Addendum No. 02

Subject: Allen M. Stearne K-8 School – Fire Alarm System Replacement
SDP Contract No. B-084C of 2018/19

This Addendum, dated April 15, 2021, shall modify and become part of the Contract Documents for the work of this project. Any items not mentioned herein, or affected by, shall be performed strictly in accordance with the original documents.

DRAWING NO.
E - 602.0
SHEET 11 OF 11

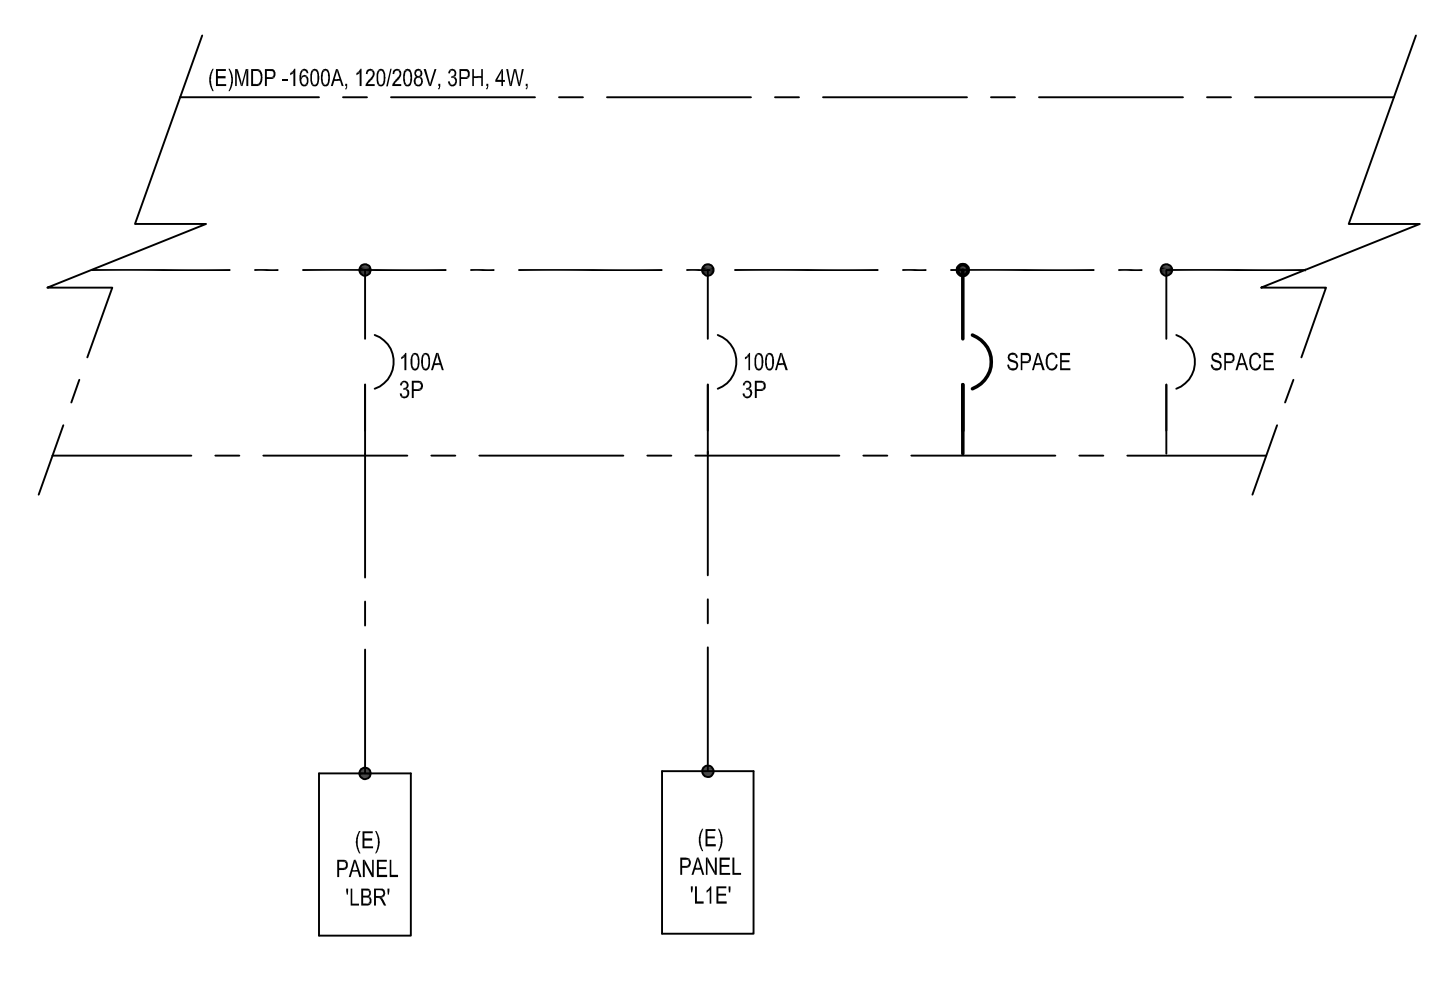
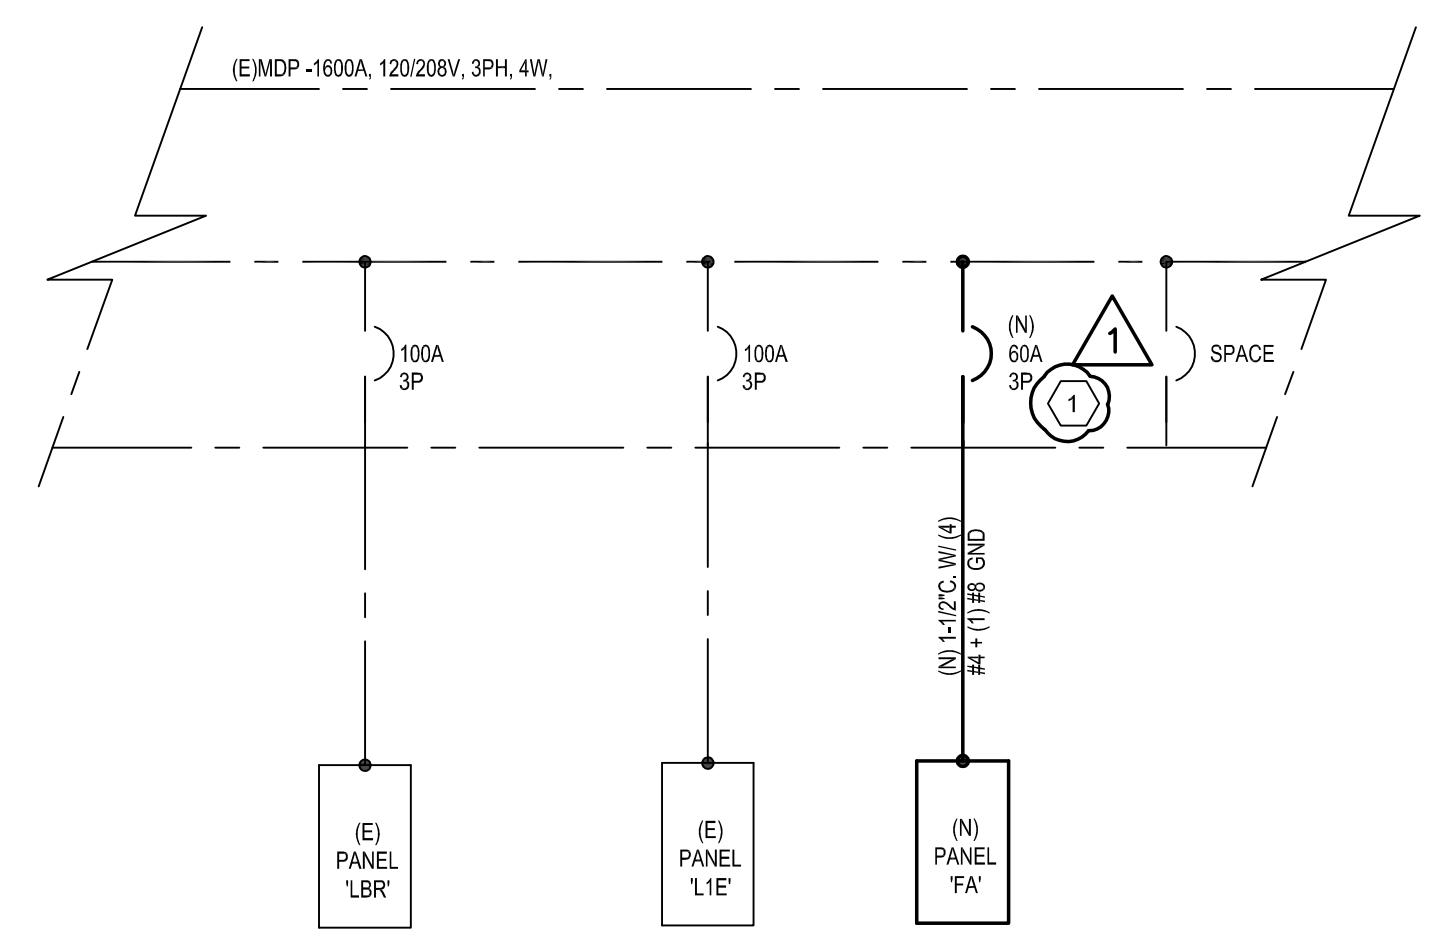
Question #20: On Drawing E602, the NAC panels are shown to be fed from panel FA. Is this correct since General Note M has them fed from existing EM panels?

Question #26: The panel schedule for panel "FA" says to provide copper bus only on drawing E-602.0. However, spec 262416-2.1(C) calls for aluminum bussing. Please clarify whether we should provide aluminum or copper bussing for panel "FA".

Question #27: The panel schedule for panel "FA" has check boxes that mark off "lugs only" and "MCB 60A". Please clarify whether we should provide an MLO panel or MCB panel.

Response – NAC panels are fed from panel FA. See revised drawings.

Response – Furnish and install copper buss panel FA.

Response – Panel FA shall include a MCB 60A. If a 10 foot tap rule is allowed per NEC for this installation then the additional circuit breaker in the MDP may be deleted with the construction manager's approval. See revised drawing.
